Re: Responses to Peer Review Comments, 500 Harvard Street
Brookline, Massachusetts

Vanasse & Associates, Inc. (VAI) is pleased to submit responses to the June 26, 2020 letter from Environmental Partners (EP) and the June 17, 2020 letter from Walker Consultants (WC), the town of Brookline's Peer Review consultants for traffic and parking. For ease of review, we have listed the comments followed by our responses. In addition, updated graphic exhibits are included in the Appendix attached to this letter.

EP Peer Review Letter – June 26, 2020

Figure EP-10

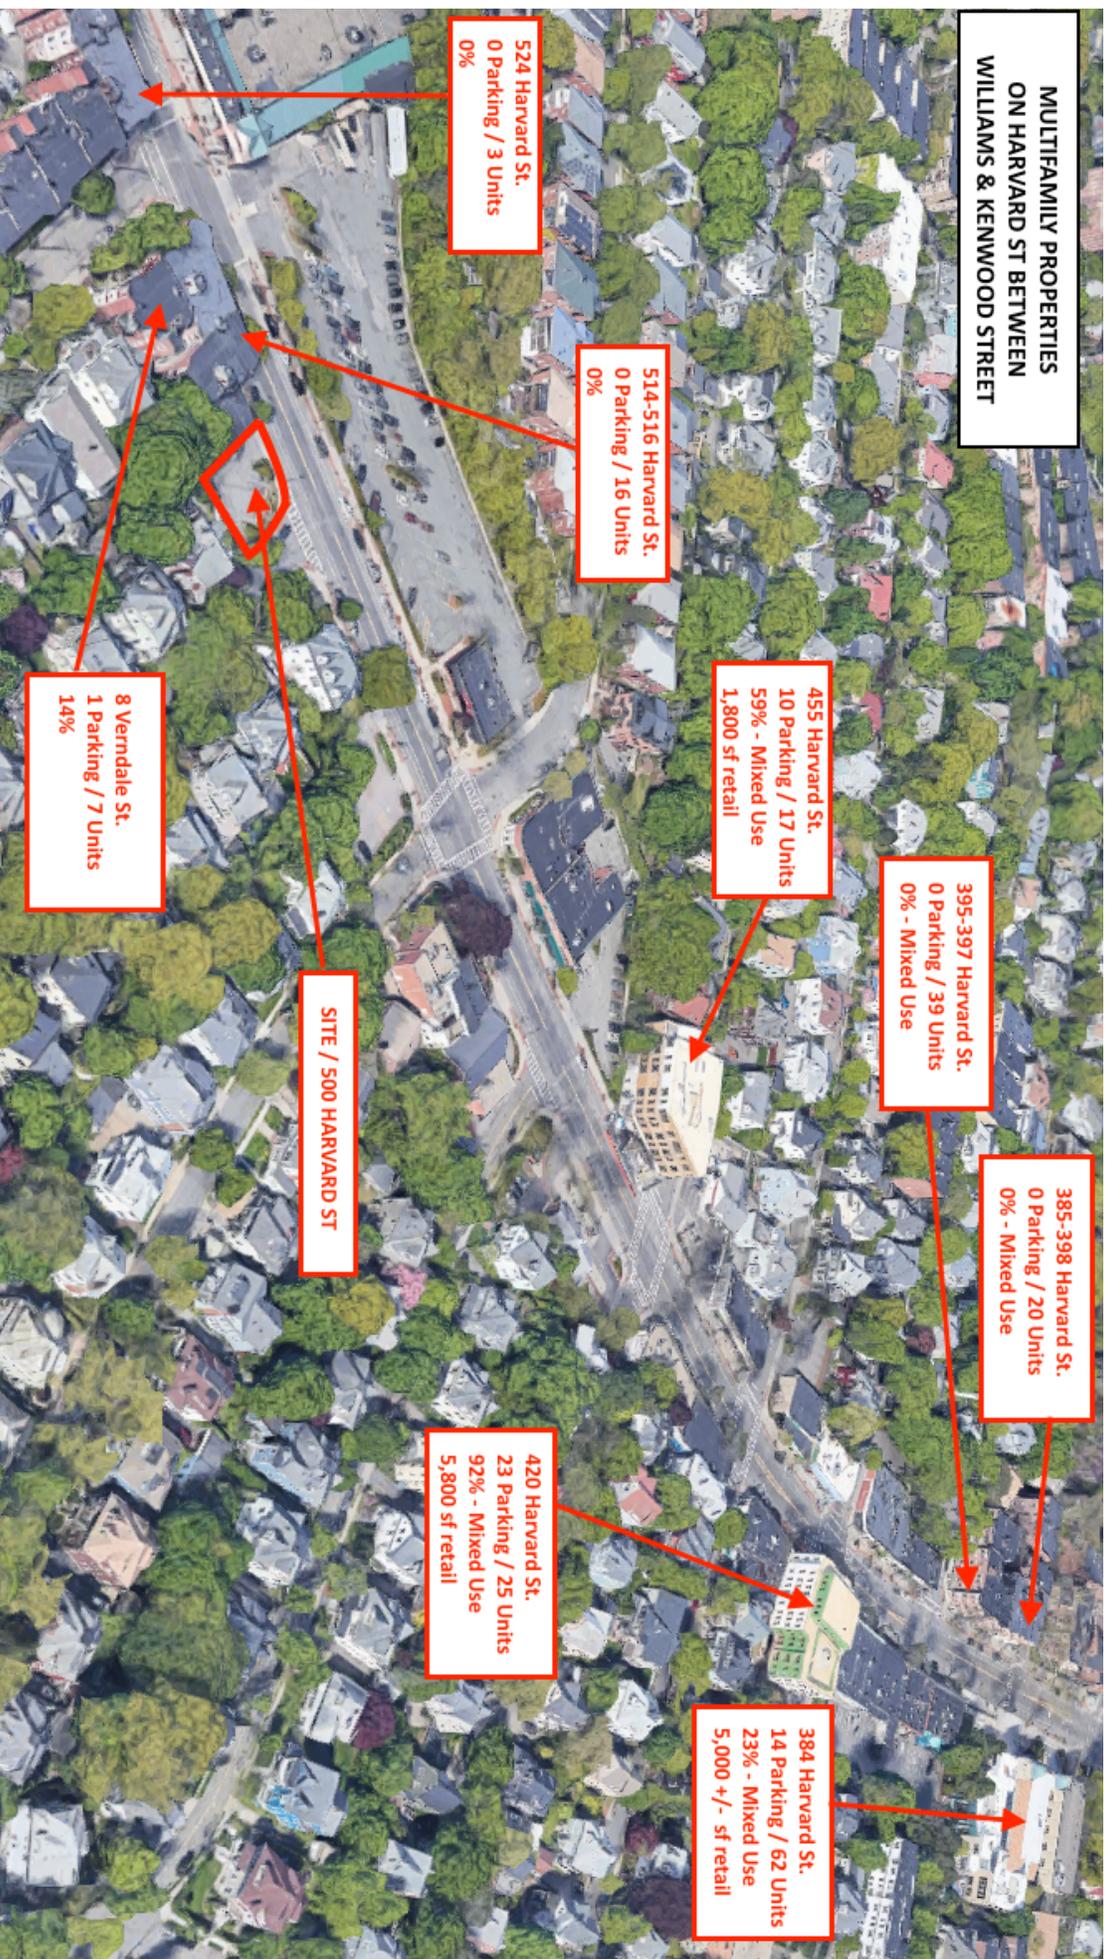
EP Comment 10: *“The Memo indicates that the projections presented in Table 3 represent a conservative scenario, as the proposed project will have only six (6) parking spaces for residents, which would lead to most residents not having vehicles and relying on alternative forms of transportation. While EP agrees that many residents will likely use alternative forms of transportation as reflected in the above trip reductions, we do not agree that there is a direct correlation between the Applicant’s proposed number of parking spaces and the number of vehicles that realistically may be owned by residents, nor does the project as currently proposed meet the zoning requirements for parking spaces as discussed in Walker Consultants’ Parking Peer Review. As such, we recommend removing this statement from the memo.”*

The location of these developments is shown in Figure EP-10 in the Appendix. Several of these developments had a TDM Plan designed to reduce the need for vehicle ownership, similar to that which the Project is providing. This is in response to a desire to address traffic congestion and the market for carless tenants by limiting parking supply for residential developments.

Figure 7R
 Site Generated
 Peak Hour Traffic Volumes

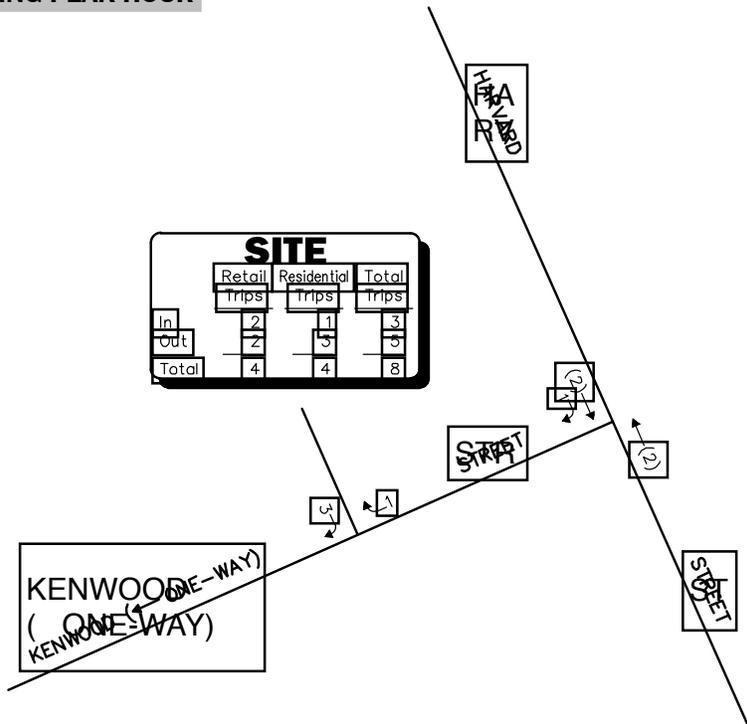
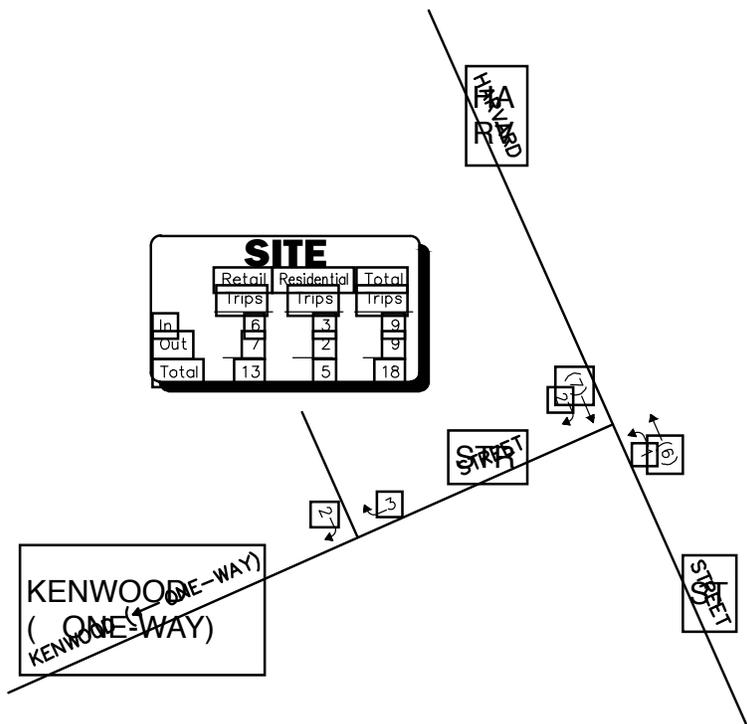
EP Comment 1: *“VAI did not study the roadways in the surrounding neighborhood despite the proposed driveway location requiring vehicles to exit onto a one-way road through the neighborhood. EP recommends consideration be made for site traffic impacts to safety for the cut-through route of exiting site traffic”*

VAI Response: It is important to note that there will only be parking for six (6) vehicles on site. Trips associated with these six parking spaces will be minor and average one vehicle every 10 minutes during the peak hours. Beyond the driveway, these additional trips will not be noticed on the roadway. There may be some confusion regarding the volume of traffic accessing the driveway, as the traffic networks conservatively assigned all (retail and residential) trips to the driveway when only the residential trips will have access to the garage and driveway. Therefore, site-generated and 2027 Build traffic volume networks have been updated to show that the retail trips will not access the site via the driveway. In fact, since the retail uses planned are to be neighborhood accessory-type stores, most of the trips are expected to be made via walking from nearby residences and not from driving. Figure 7R in the Appendix shows the site-generated networks while Figure 8R shows the 2027 Build networks.

As shown in Figure 7R, 3 vehicles exit the site during the weekday morning peak hour and 2 vehicles exit during the weekday evening peak hour. It is reasonable to assume only a fraction of this exiting traffic would desire to access Harvard Street directly. Conservatively assuming 50 percent of traffic desires to access Harvard

Street directly after exiting the proposed site, indicates that 1 to 2 vehicles during the peak hours would travel Kenwood Street to Columbia Street, just as the existing residents living on Kenwood Street currently do. The impact of 1 to 2 additional vehicles, even on residential streets like Kenwood Street, is negligible and therefore does not justify expanding the study area.
